**Response to Comments on  
Draft Remedial Action Completion Report for LHAAP-03  
Longhorn Army Ammunition Plant, Karnack, Texas**

**Document Date: 10 February 2021  
Comment Date: 1 March 2021**

**Reviewer: April Palmie, TCEQ  
Respondent: Dr. Rose Zeiler**

*Draft Final*  
Remedial Action Completion Report,  
LHAAP-03 Former Waste Collection  
Pad, Building 722-P Paint Shop  
Longhorn Army Ammunition Plant  
Karnack, Texas

Figure 2-3  
Completed Excavation Boundaries  
LHAAP-03  
Remedial Action Completion Report  
LONGHORN ARMY AMMUNITION PLANT  
KARNACK, TEXAS

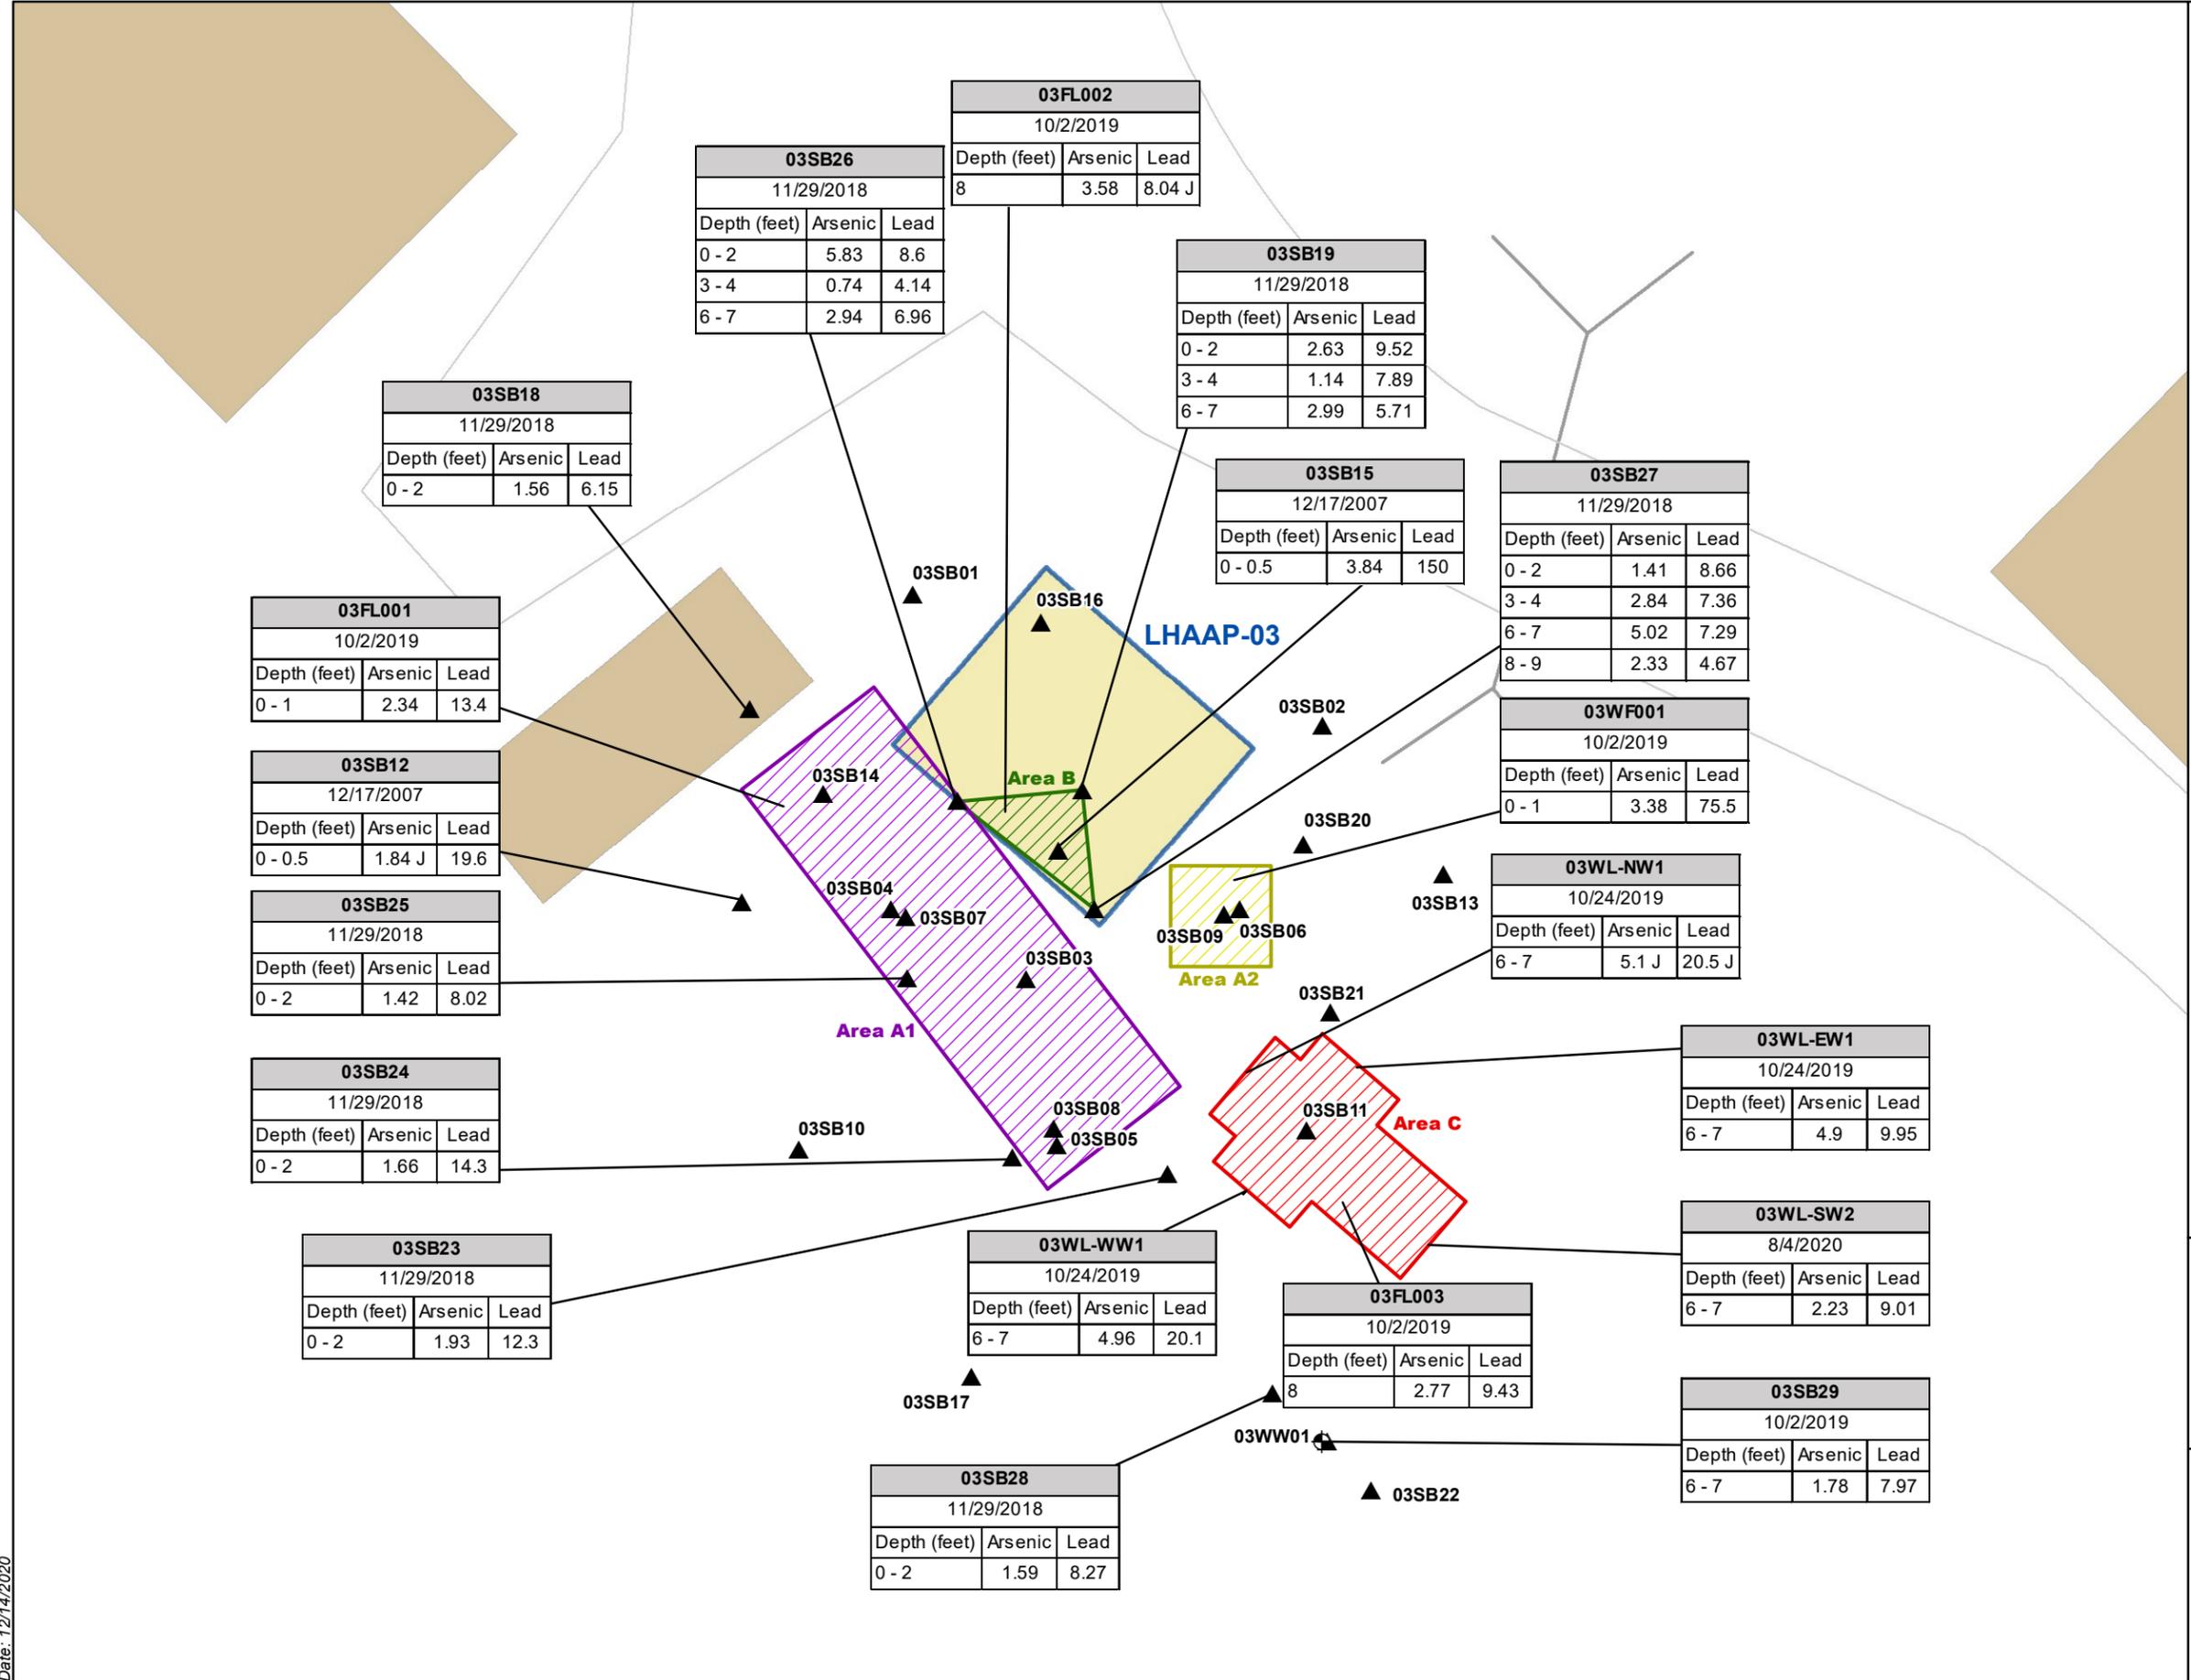
4.	Section 2.2; Page 2-3	Revise sentence as shown (or similar):  <b>Area C.</b> This area remained unchanged from the ROD (Bhate 2018a), but the locations of <b>was detached from Area C and</b> monitoring well 03WW01 <b>were corrected</b> as described in <b>Section</b>	C	Text will be revised to “This area remained unchanged from the ROD (Bhate 2018a), but the locations of Area C and monitoring well 03WW01 were corrected, as described in <b>Section 1.4</b> and <b>Section 2.1.1</b> , due to a discrepancy identified in the field between the 2007 location of 03SB11 and the 2008

- **Area C.** This area remained unchanged from the ROD (Bhate 2018a), but the locations of Area C and monitoring well 03WW01 were corrected, as described in **Section 1.4** and **Section 2.1.1**, due to a discrepancy identified in the field between the 2007 location of 03SB11 and the 2008 03SB11 sample location that was converted into monitoring well 03WW01. The excavation was centered on the 2007 location of 03SB11, where contamination was identified at 6 to 7 feet bgs and was initially excavated as an 8- by 8-foot-square excavation approximately 8-feet-deep (**Figure 2-3**). The floor confirmation sample did not contain COC concentrations exceeding the LHAAP-03 cleanup values. However, as described further in **Section 3.0**, the four-wall composite confirmation sample exceeded the cleanup value for arsenic. Following removal of rainwater accumulated in the excavation on October 12, 2019, a second four-wall composite sample was collected and again exceeded the cleanup value for arsenic. On October 24, 2019, following removal of rainfall runoff that accumulated in the excavation, Area C was overexcavated by approximately 2 feet in each direction. Individual confirmation samples collected on October 24, 2019, for the east, west, and north walls contained COCs below the cleanup values. The south wall sample contained arsenic exceeding the cleanup level. The south wall was excavated an additional 5 feet, and the confirmation sample collected on August 4, 2020, did not contain COC concentrations exceeding the LHAAP-03 cleanup values.
